CITRUS COUNTY

**RE: PENDING MODIFICATION OF CONDITIONS - PERMIT NO. S009-187229
CITRUS COUNTY CENTRAL LANDFILL - CITRUS COUNTY**

Following is the additional information submittal as stated in letter dated December 14, 1992.

FIGURE 1

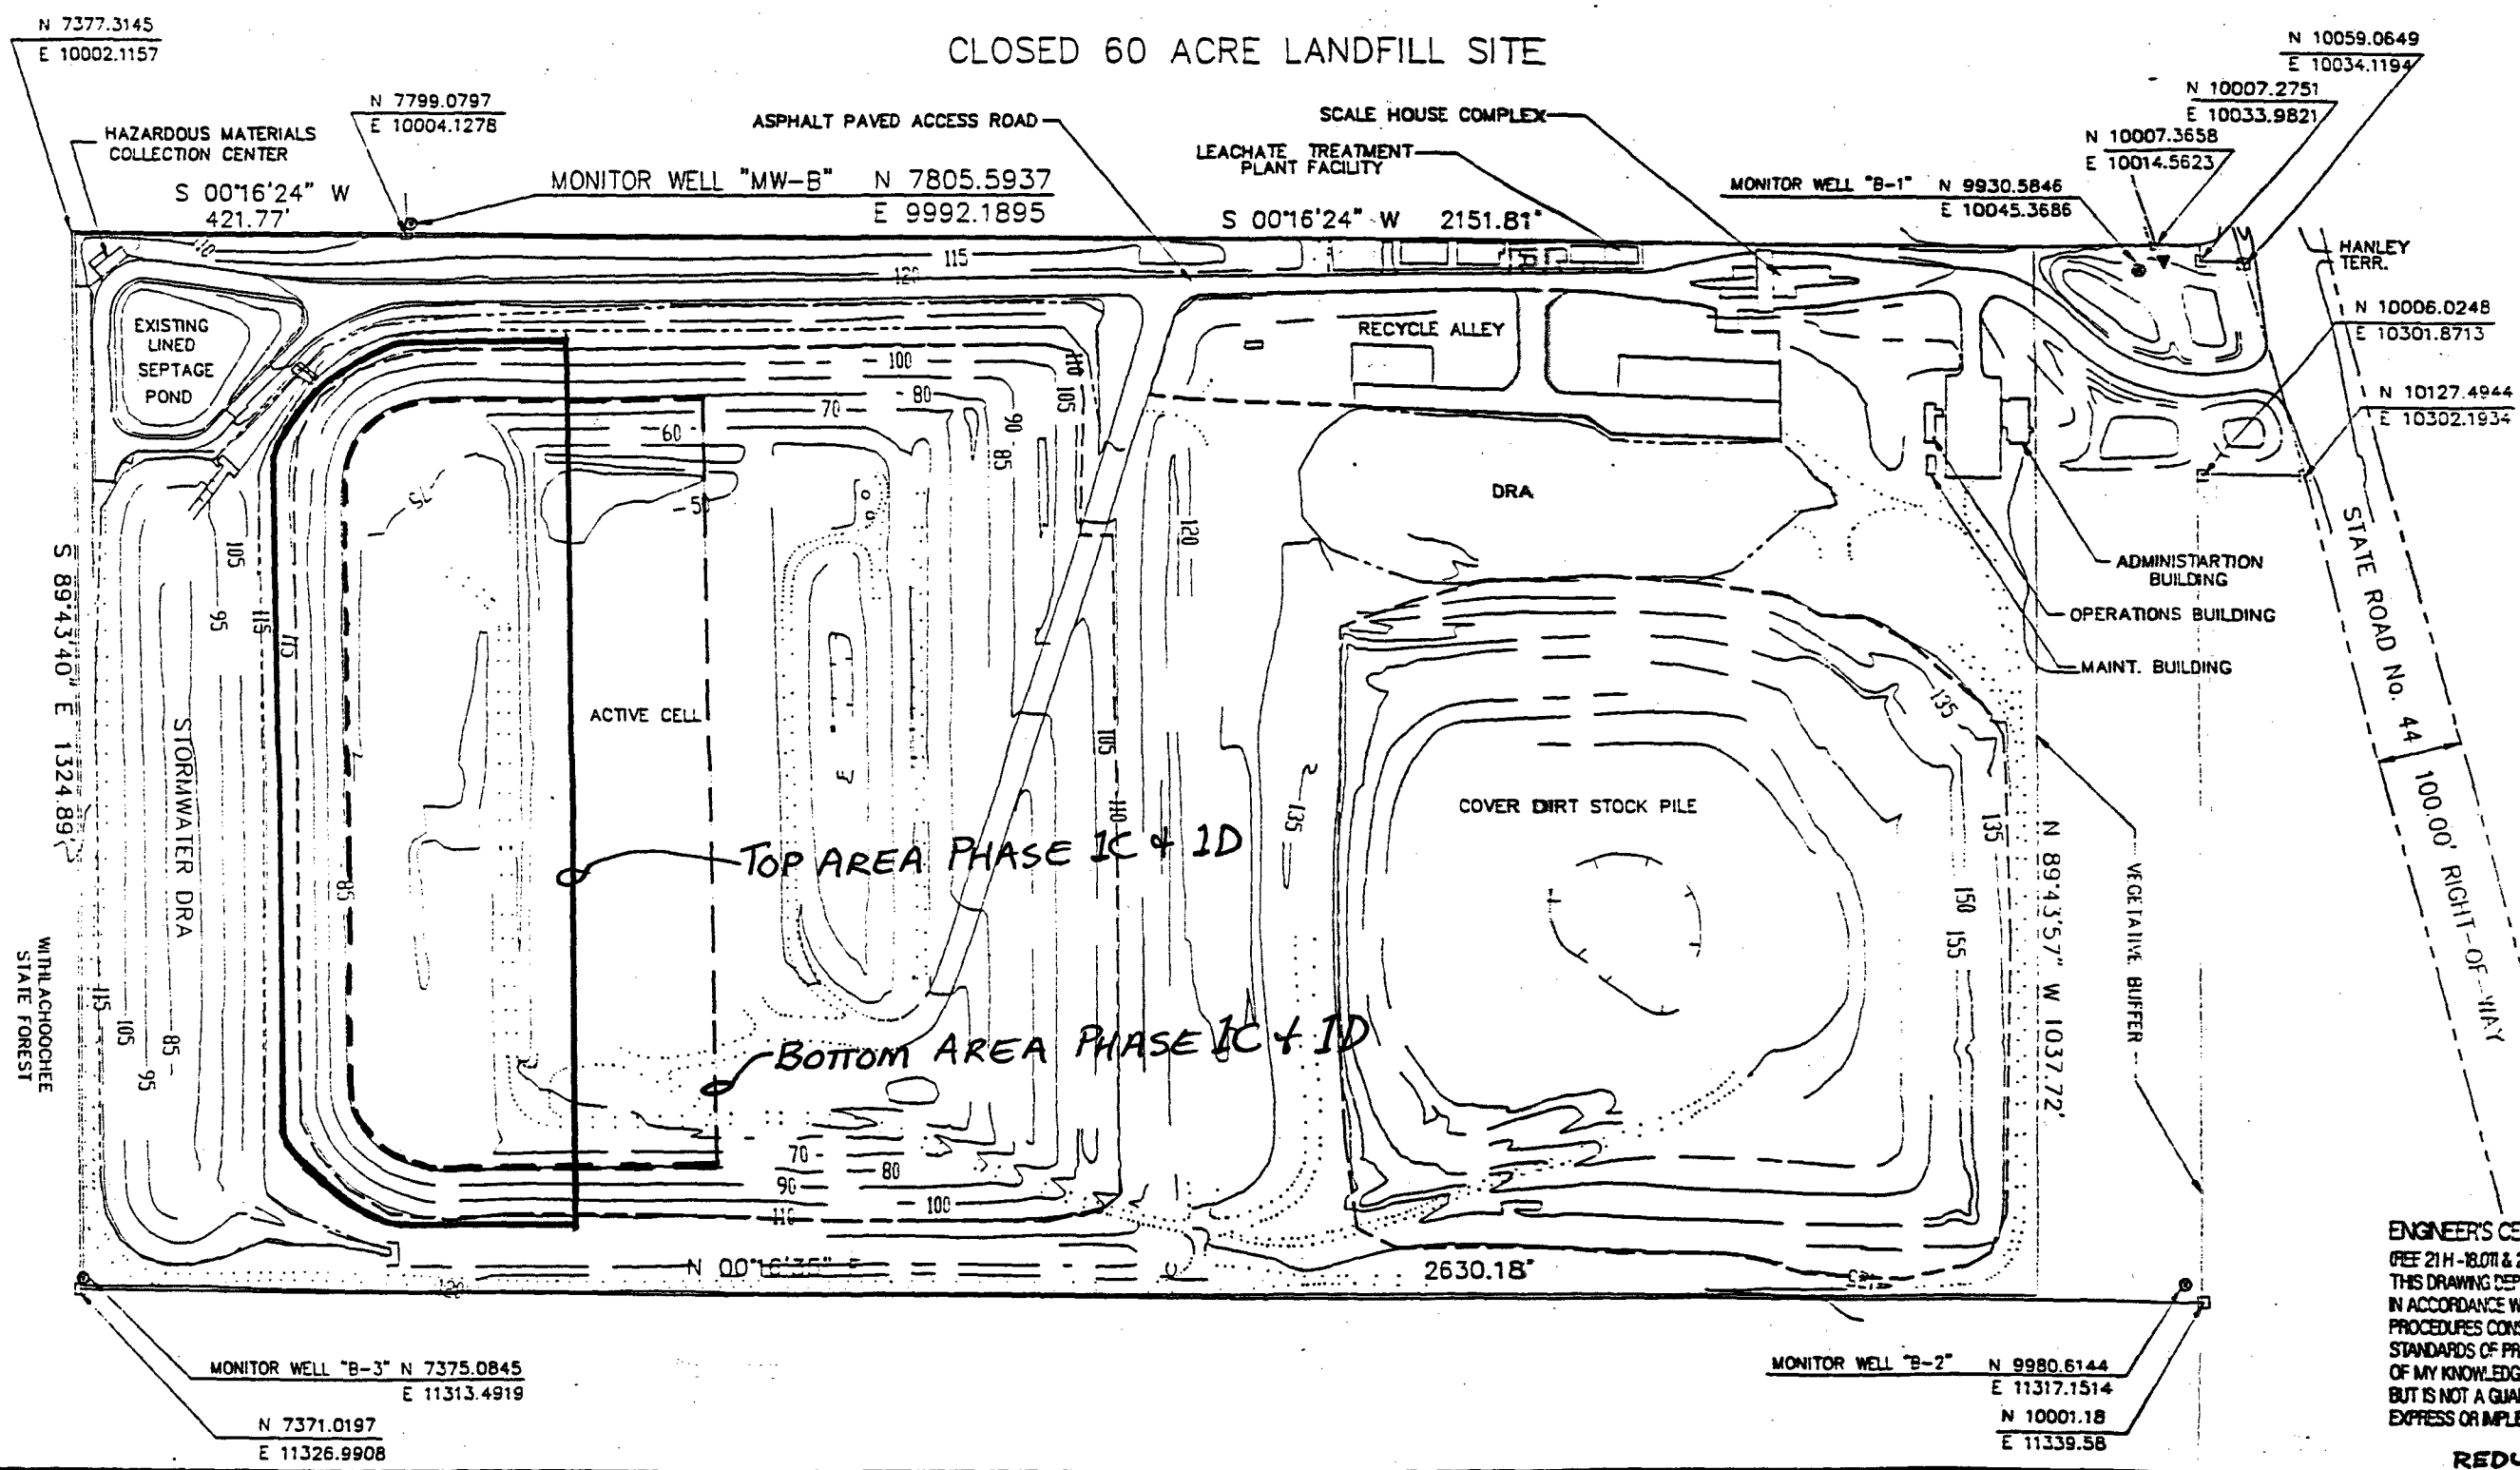
This area is bounded by the upper edge of the liner (Elevation 120), and on the north side, by the 4:1 fill slope up from the 80 foot bottom area. Refer to Figure 1 where the maximum extent of both top and bottom areas of Phase 1C and 1D are shown. An area equal to or greater than that represented by a 250' x 1035' rectangle is available.

Using these areas and a separation of 40 vertical feet, and using the average end area formula, a volume of 438,889 cubic feet can be calculated. This is conservative.
